New Albany Architectural Review Board Meeting Agenda
Monday, January 12, 2026, 7:00 p.m.

ARB-102-2025 Village Center Mixed-Use Development Modifications COA

**HEALTHY NEW ALBANY FOOD PANTRY
FINAL DEVELOPMENT PLAN
CERTIFICATE OF APPROPRIATENESS**

LANDSCAPE PLAN

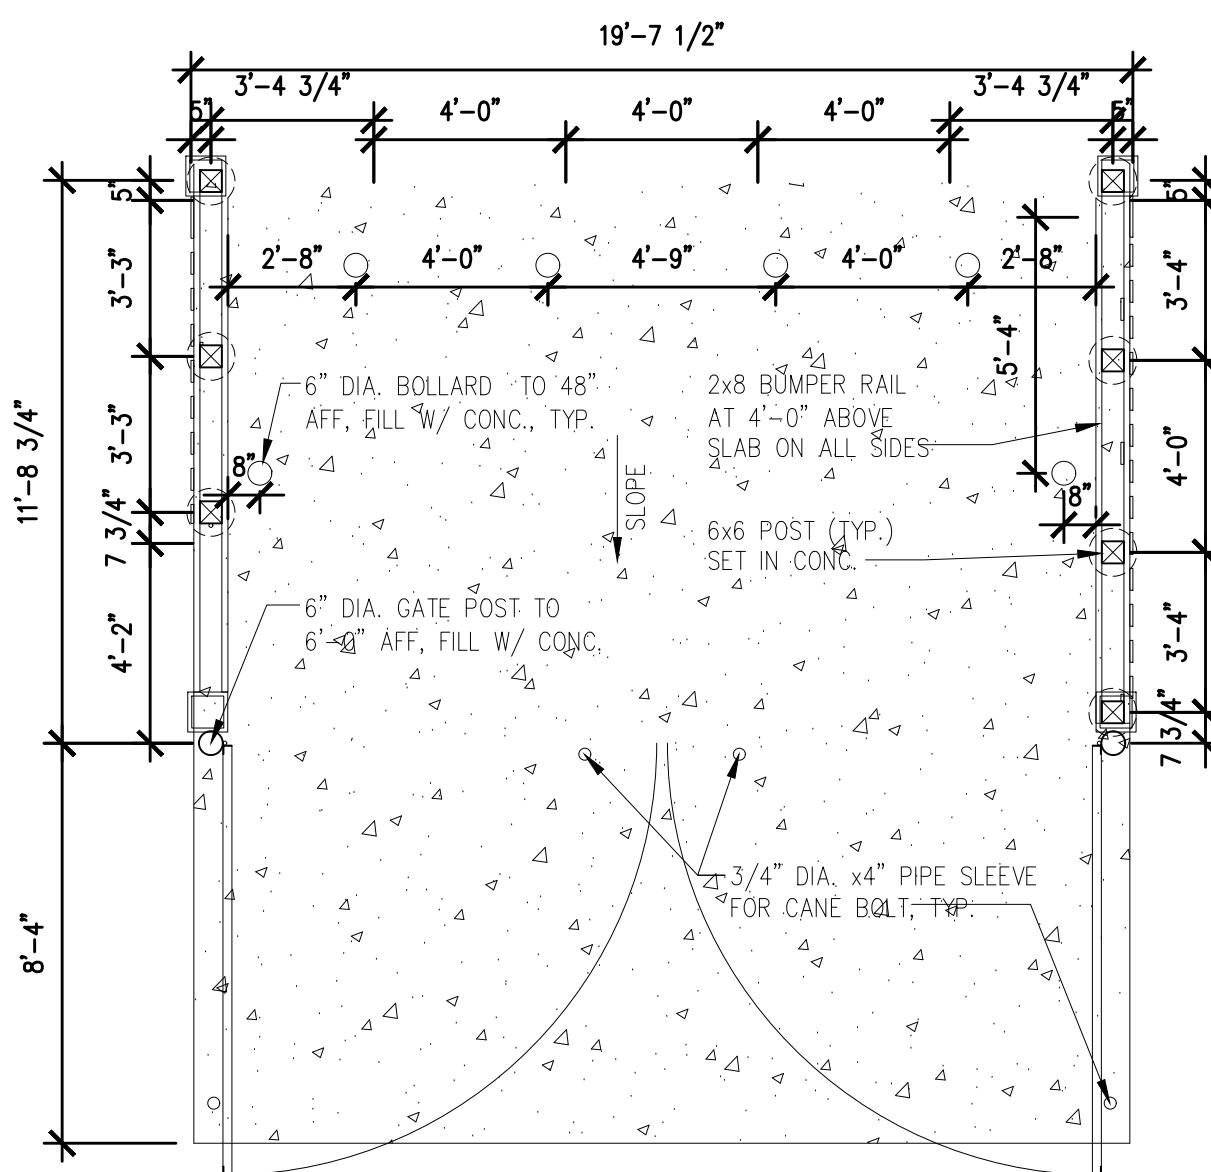
- Provide proposed grading for the on-site retention basin in accordance with City of New Albany standards.
 - Consider revising the proposed placement of the trees in front of the building to be more consistent with the existing buffer planted along the remainder of the parcels boundary.

- Narrow the main drive connection from Harlem Road to the parking lot, referencing the adjacent church property for guidance on widths.
 - Revise the proposed landscape plan to include the proper planting along the edge of the outlined basin, where possible.

**Building A // South Elevation**

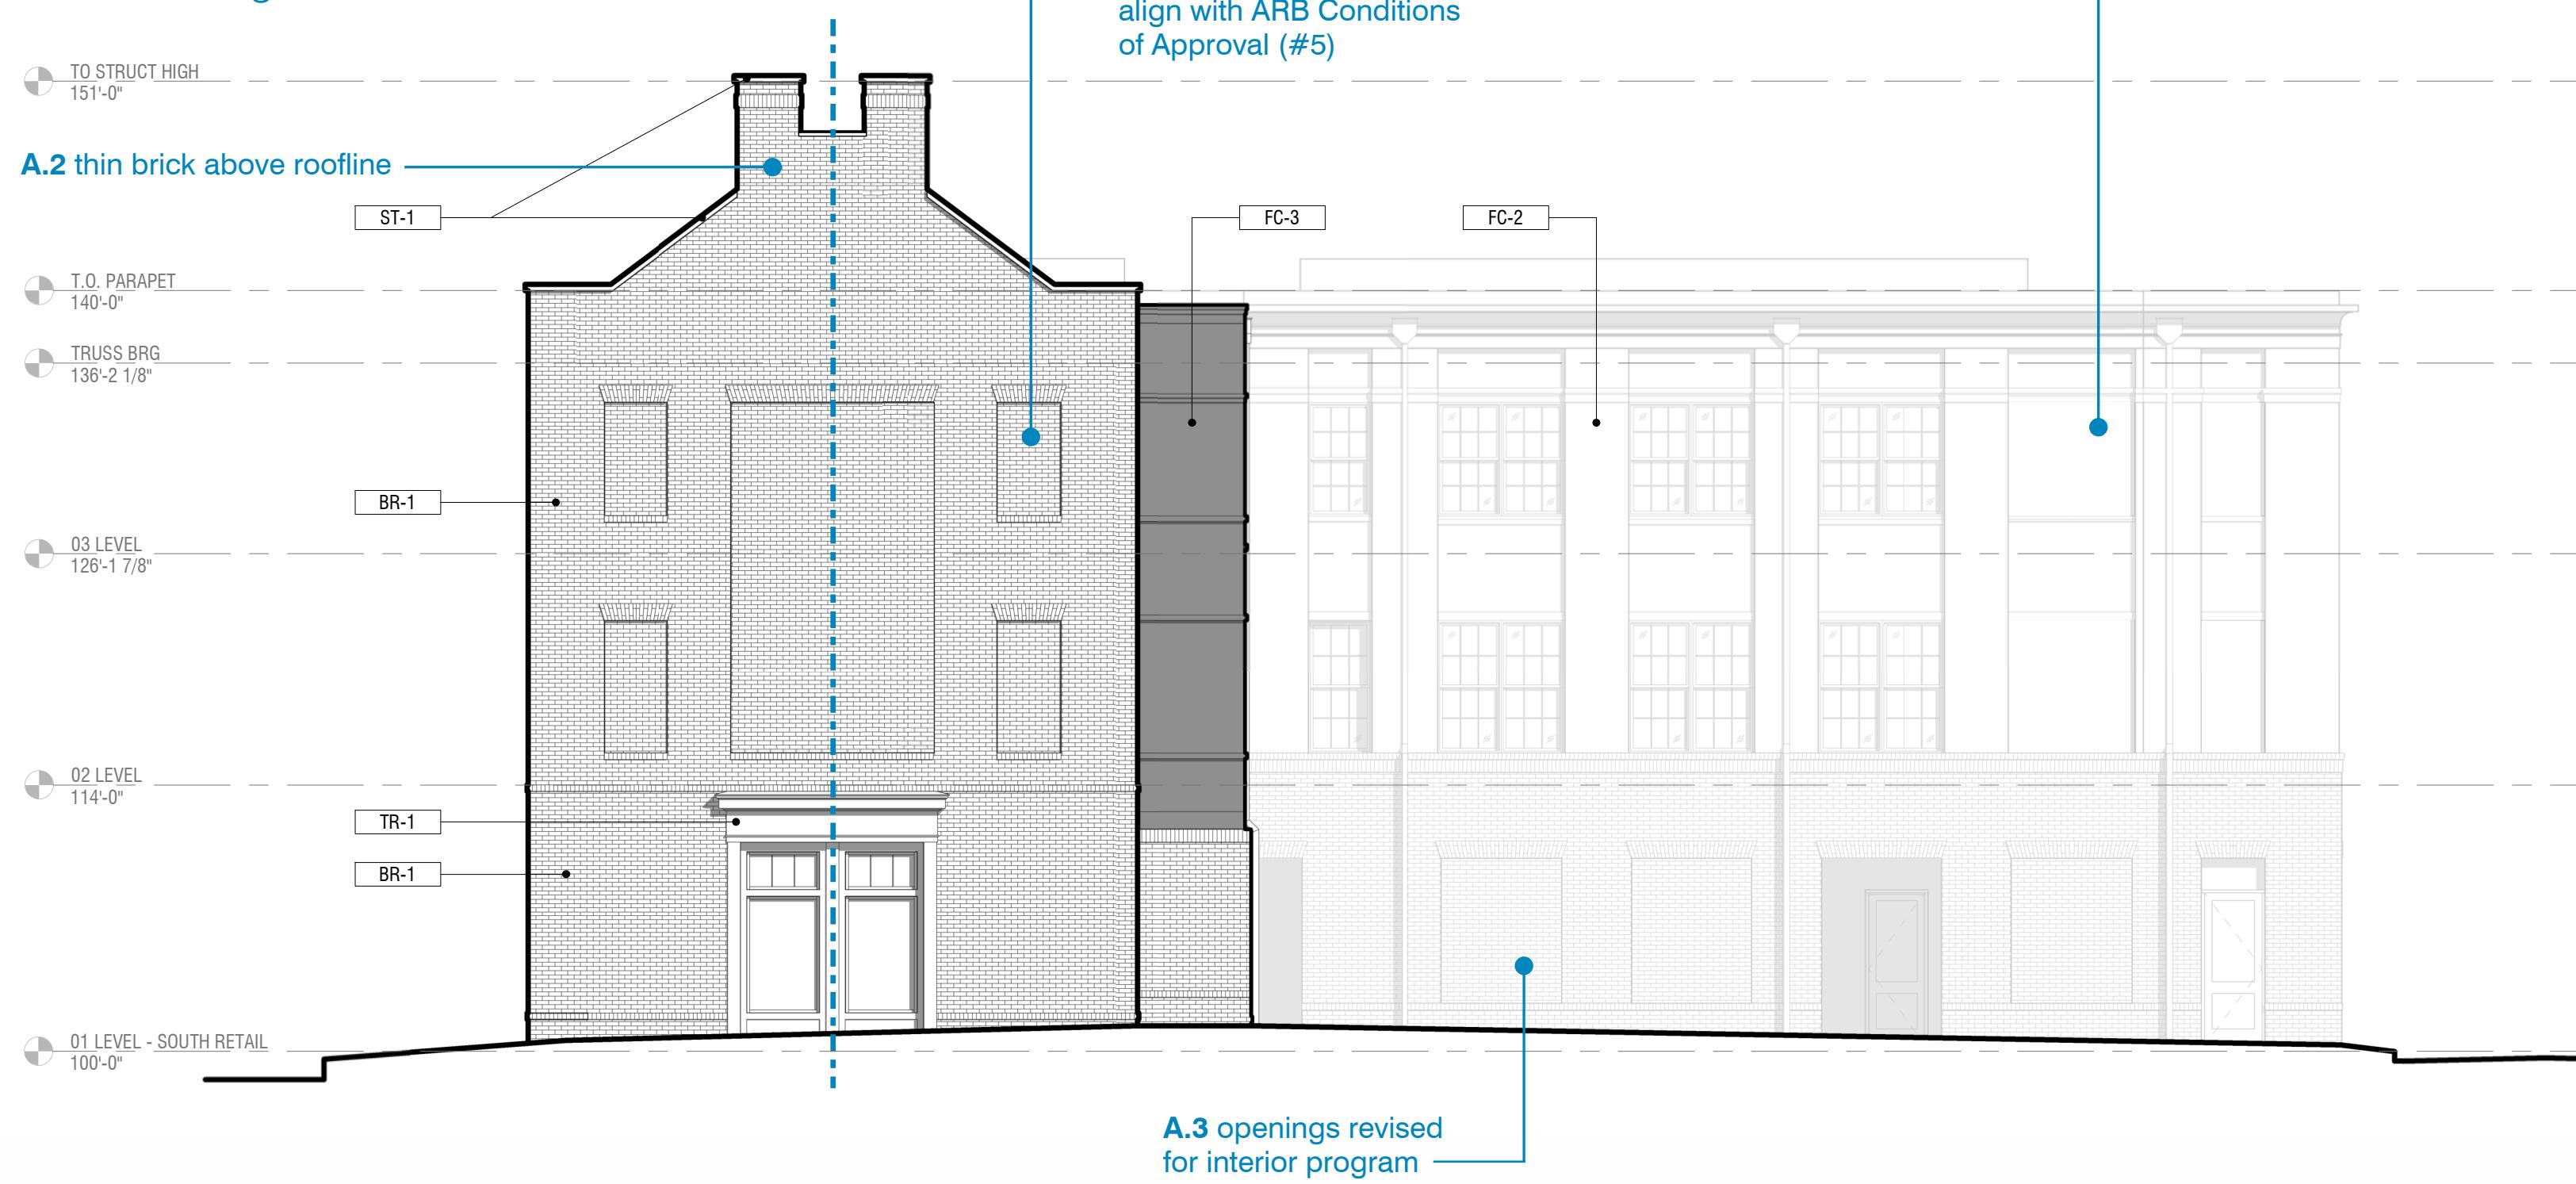
3. Maintain common radii for all segmented arches
Refer to Building A and B elevations. The arches were modified to match those of Building A.
4. Consider added fenestration on the south elevation of sub-area A in step with the city architect's recommendations
Elevation modified to prioritize traditional symmetry. See condition 5 below, and Building A South Elevation on sheet A3.

5. That the applicant enhances the south façade to adhere to a strict centerline, subject to staff approval.
The brick recesses and first level storefront were modified and centered in the façade to achieve bilateral symmetry. Refer to Building A South Elevation on sheet A3.
